Agenda
City of Springboro Planning Commission Meeting
Wednesday, March 8, 2023, 6:00 p.m.
Council Chambers, City Building, 320 West Central Avenue

Site Plan Review, 800 West Central Avenue (SR 73), proposed Sheetz fuel center, convenience store/restaurant

Site Plan Review, 25 West Central Avenue (SR 73), new bank branch for River Valley Credit Union

Concept Elevations

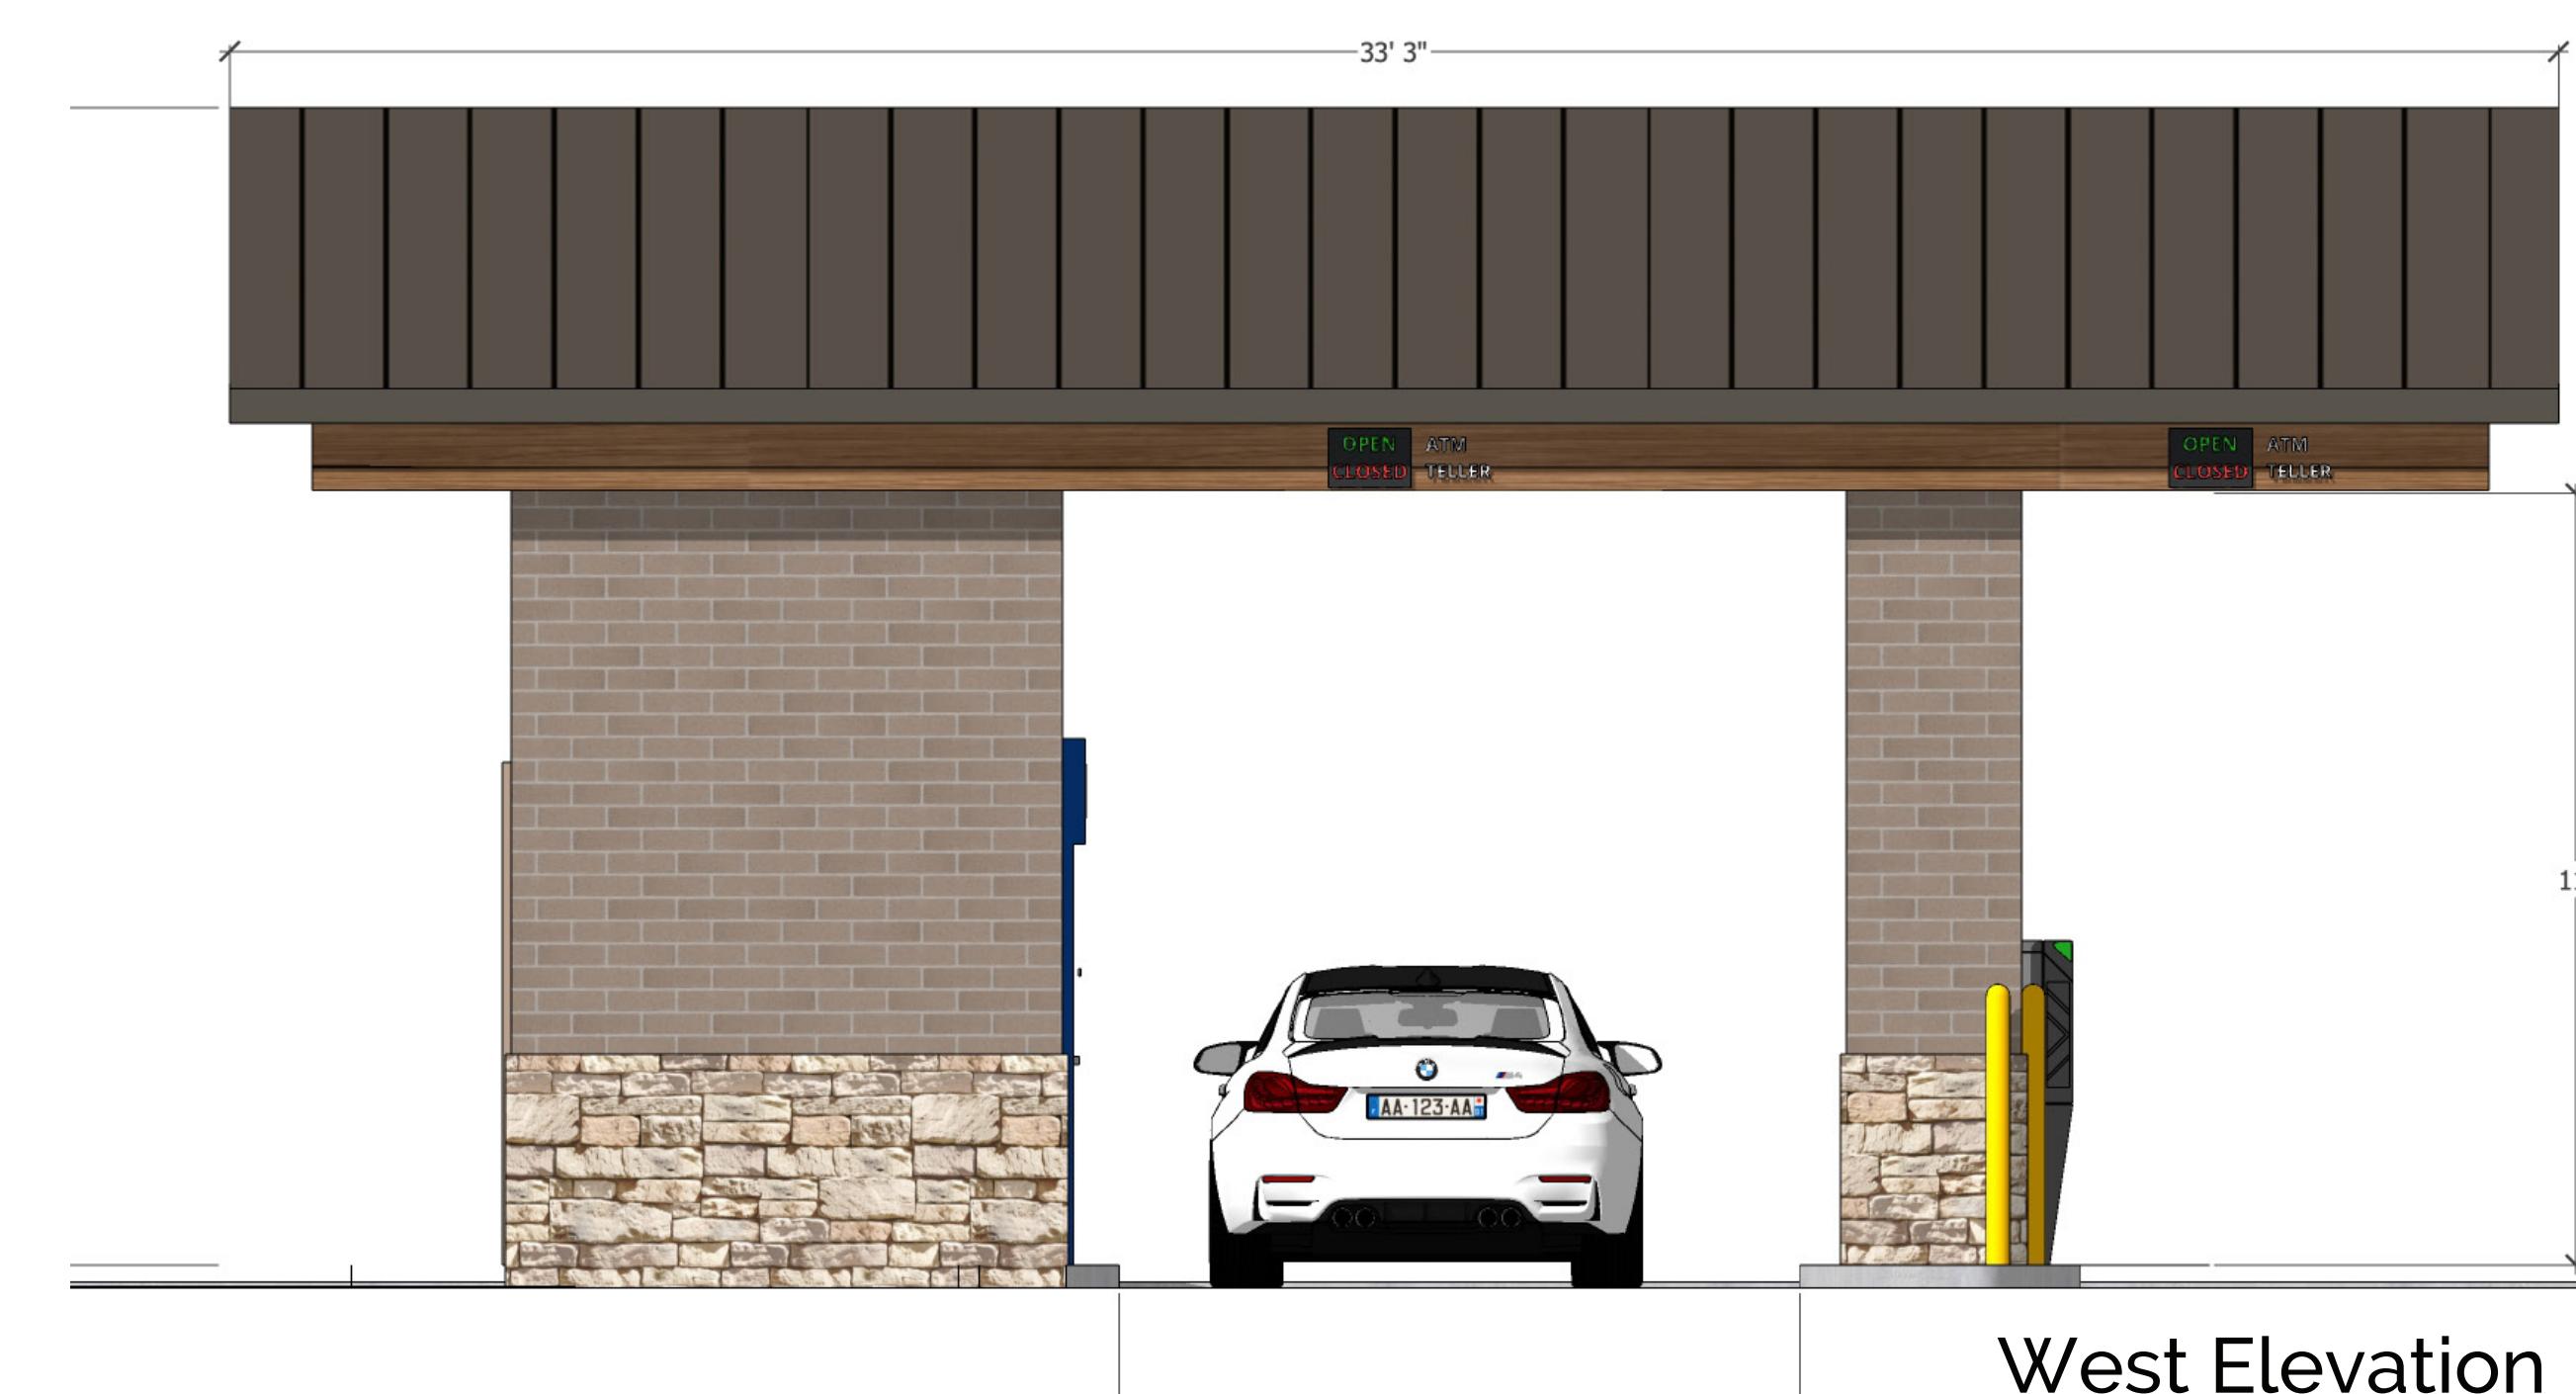
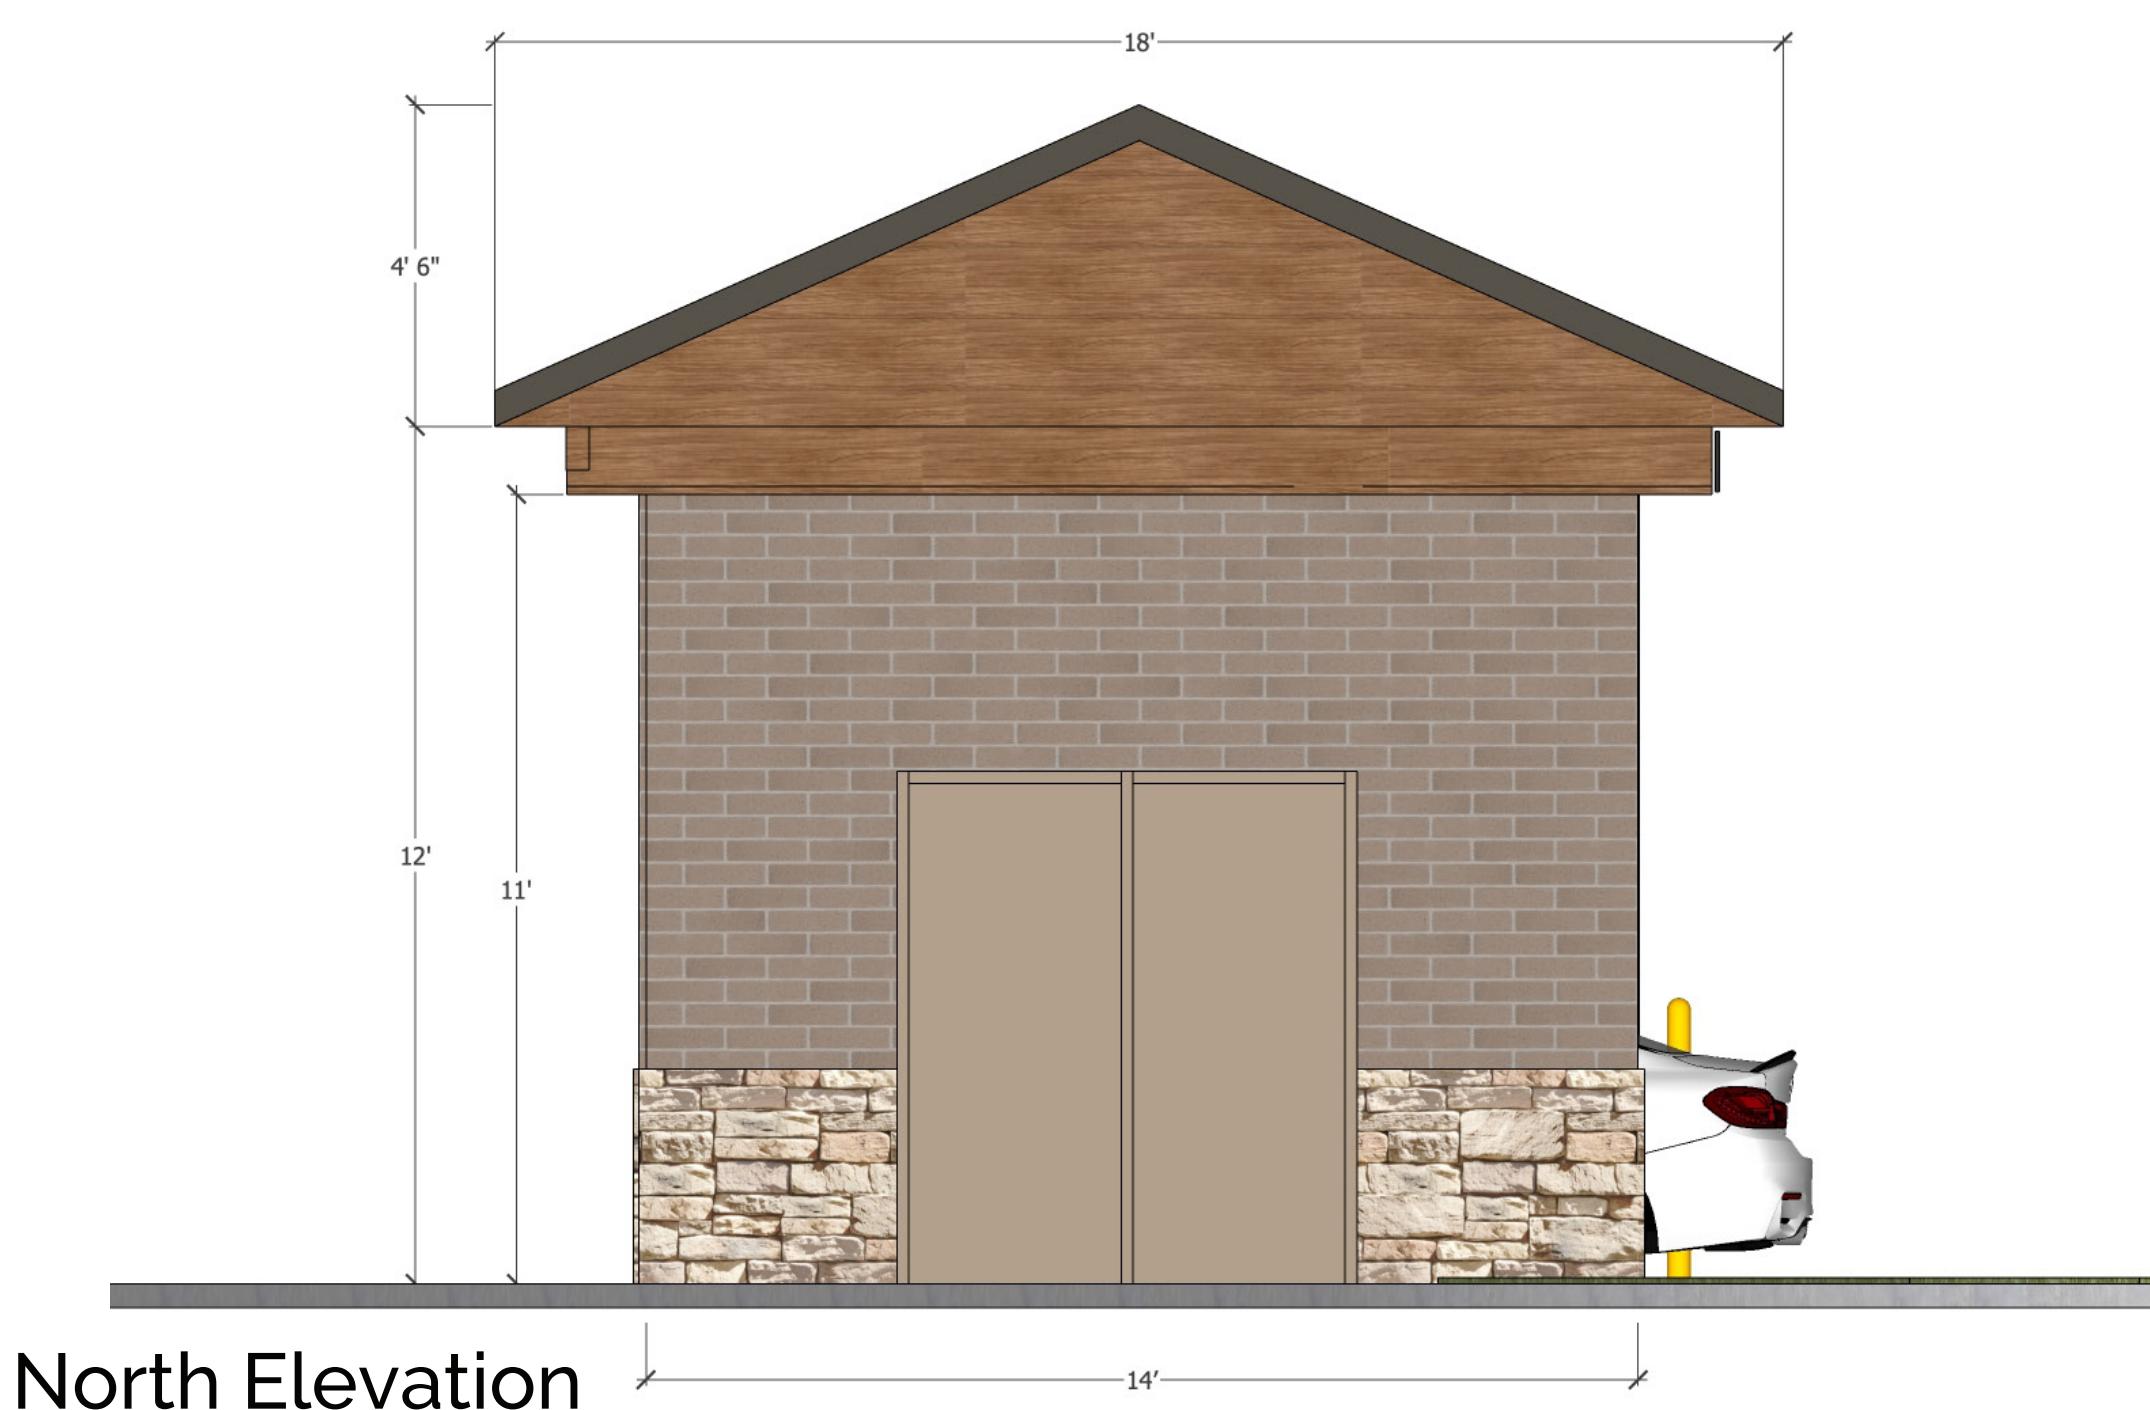
5. Provide dimensions to property line for proposed sign and accessory structure on Florence Drive frontage.
6. Revise east (Florence Drive) and south elevations to meet four-sided architecture requirement. See UVD Section 1267.08(a)(1) (typical citation through comment #13), and orientation to street requirements. Section 1267.08(a)(2).

7. Windows on east elevation to meet vertical orientation requirement. Section 1267.08(a)(3). Also verify all glass to meet material requirements. Section 1267.08(a)(4).

9. North (West Central Avenue) and east (Florence Drive) elevations to meet 65% opacity requirement. Section 1267.08(a)(10).
10. Landscaping to be reviewed following preliminary review of site plan in light of Section 1267.09 and Chapter 1279, Landscaping.
